Environmental Protection Authority

NOTICE OF DECISION TO CONSENT TO AMEND A REFERRED PROPOSAL DURING ASSESSMENT

Cockatoo island multi-user supply base Assessment No. 2314

Figure 1: Development Envelope and Disturbance Footprint

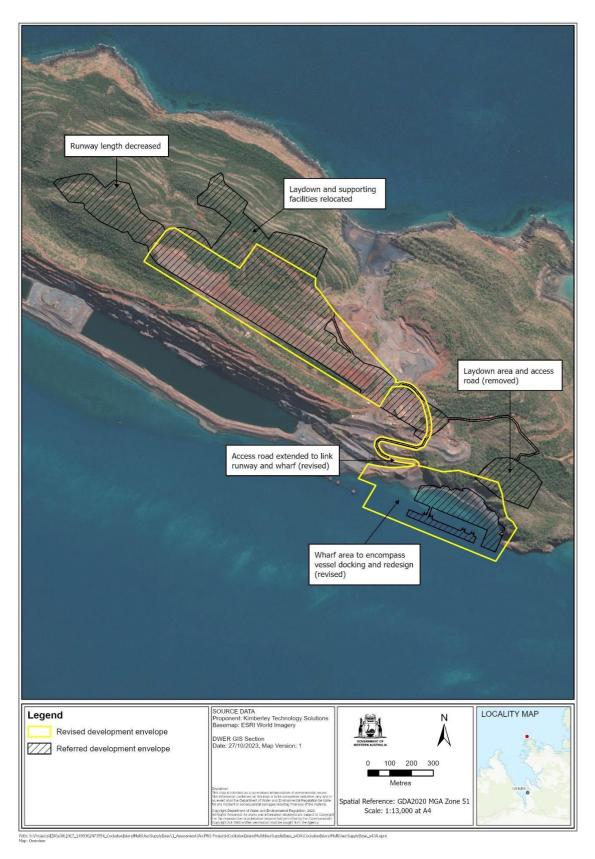
- an increase in the size of the development envelope from 52.66 ha to 52.81 ha
- a reduction in indicative disturbance footprint of the airfield, apron and supporting infrastructure from 36.46 ha to 18.84 ha
- the relocation of supporting infrastructure (laydowns, hangar, and helipad) from areas of native vegetation to previously disturbed land and/or the wharf area
- a reduction in area of land reclamation for the wharf from 6.18 ha to 5.75 ha
- the addition of 0.82 ha floating wharf component
- changes to wharf design and construction methodology.

Proposal element	Location / description	Existing extent, capacity or range	Proposed amendment	Combined extent, capacity or range			
Physical elements							
Airfield, apron and support infrastructure	Figure 1	Total footprint of 36.46 ha (with no more than 20.61 ha of vegetation clearing) within the 52.66 ha Development Envelope.	Reduction in both overall footprint of 17.76 ha and vegetation clearing of 13.24 ha.	18.84 ha (with no more than 7.37 ha of vegetation clearing).			
Laydown Areas	Figure 1	Total footprint of 15.17 ha (with no more than 13.45 ha of vegetation clearing).	Removal of all proposed laydown areas. To be included within wharf element.	0 ha			
Roads	Figure 1	Total footprint of 1.03 ha (with no more than 0.17 ha of vegetation clearing).	No clearing or construction required.	0 ha

1	Т	Г	Т		
Wharf	Figure 1	Land reclamation of approximately 6.18 ha	Reduction in land reclamation of 0.43 ha and addition of 0.82 ha of floating infrastructure. Inclusion of laydown element within.	Land reclamation of no more than 5.75 ha and floating infrastructure of area 0.82 ha (contained within the 52.81 ha Development Envelope).		
Construction elen	nents					
Land Reclamation	Figure 1	756,000m³ of fill (benign mine waste)	Reduction in fill volume of 56,000m ³ based on smaller footprint.	Up to 700,000m³ of fill (benign mine waste)		
Operational elem	ents					
Wharf (floating barge)	Figure 1	New element	Additional of two floating barges 0.82 ha	Two floating barges – up to 0.82 ha		
Proposal element	Proposal elements with greenhouse gas emissions					
Construction elen	nents:					
Scope 1	Not provided at time of original referral		Scope 1 GHG emissions associated with construction are not expected to be greater than 50,000 tCO2-e per annum (assuming 1 year construction period), which places the Proposal below the 100,000 tonnes CO2-e per annum threshold, as defined under the Australian Government's Safeguard Mechanism.
